Montenegro
Ministry of Spatial Planning,
Urbanism and State Property

QUESTIONS AND ANSWERS

**COMPETITION FOR CONCEPTUAL ARCHITECTURAL DESIGN
FOR THE MUSEUM OF CONTEMPORARY ART, NATURAL HISTORY MUSEUM AND THE PARK
OF ARTS & CULTURE AND OTHER CONTENTS IN THE FUNCTION OF CULTURE**

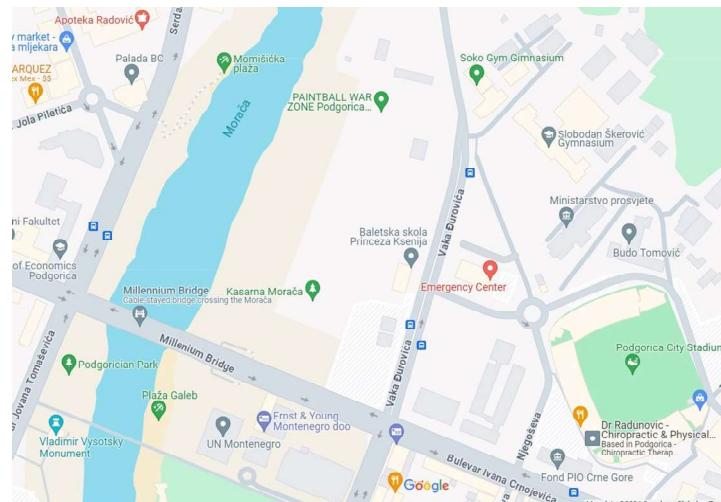
2. Could you give more information or possible simple diagram regarding the street and boulevard locations mentioned in chapter "2.4 Vehicle and pedestrian solution" from the Competition Brief? At the moment there is no simple diagram to indicate which street or boulevard is which? Only the Millennium Bridge is pretty obvious indicated and recognized as the main infrastructure feature closed to the competition site.

2. Please see the image below:
